CITY OF DUNEDIN
REVIEWED FOR
CODE COMPLIANCE

COVER SHEET

A.E.C.S. 18046 MODEL 2749

**INVENTORY LOT 5
DUNEDIN COVE
29 CONCORD DR.**

FRONT ELEVATION

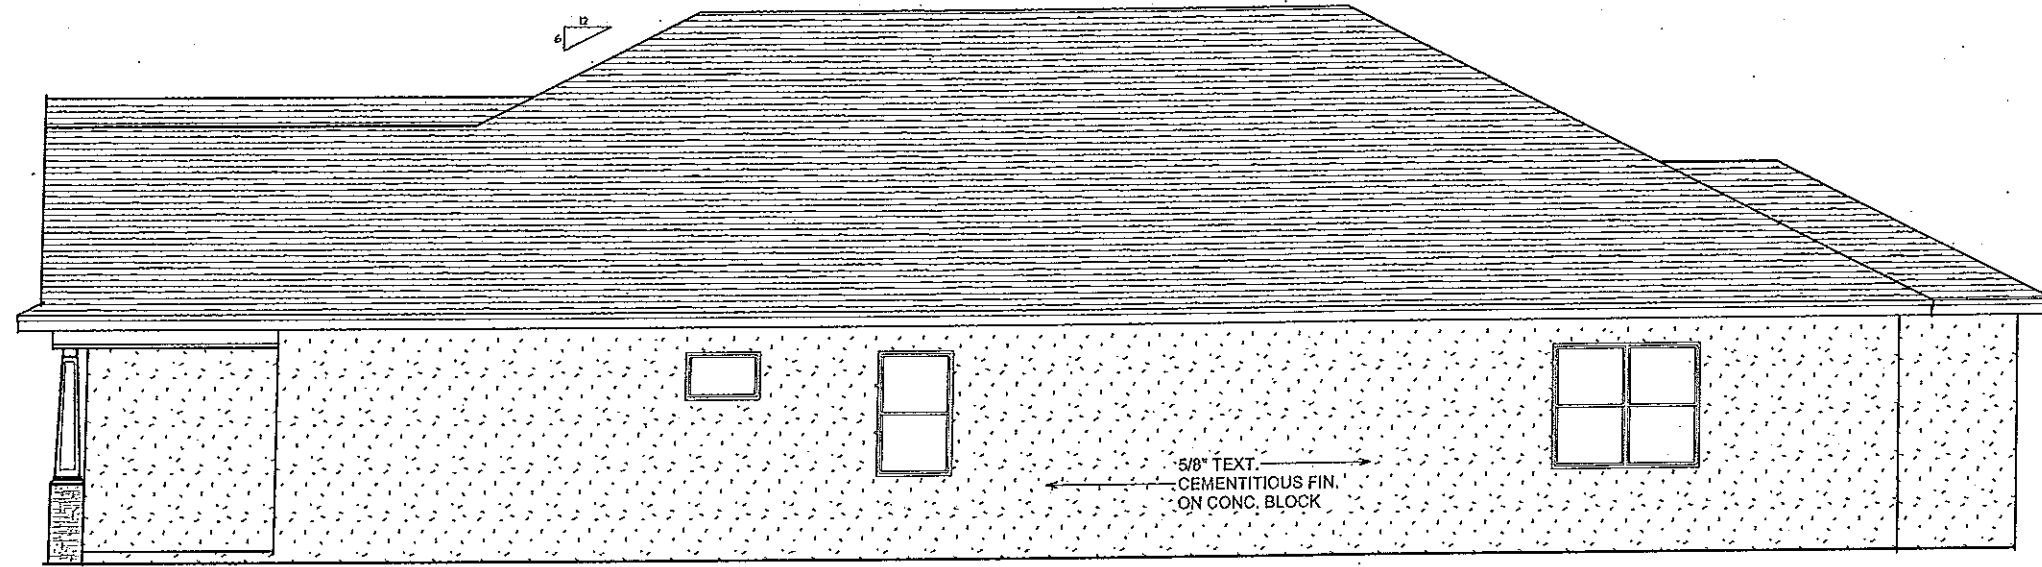
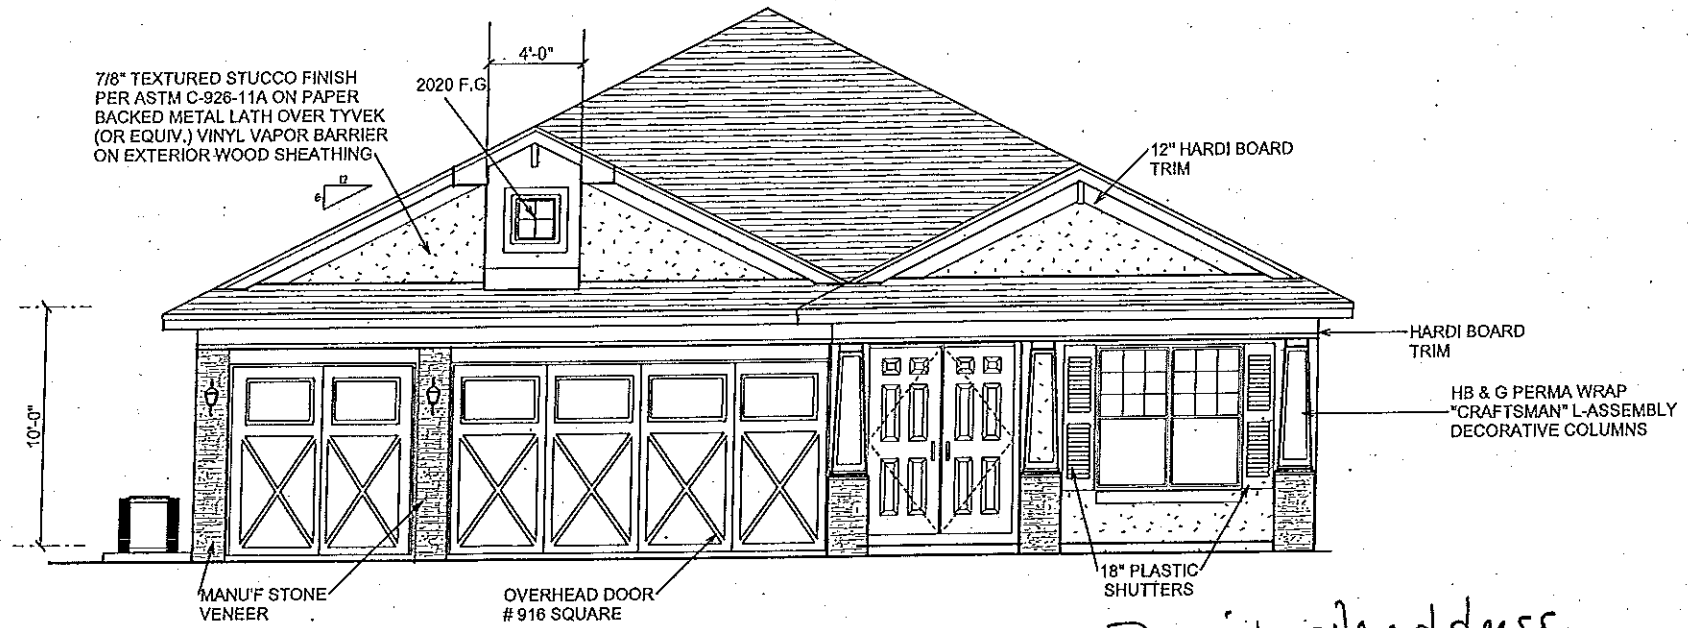
Provide site address per B319FBC-R 2017
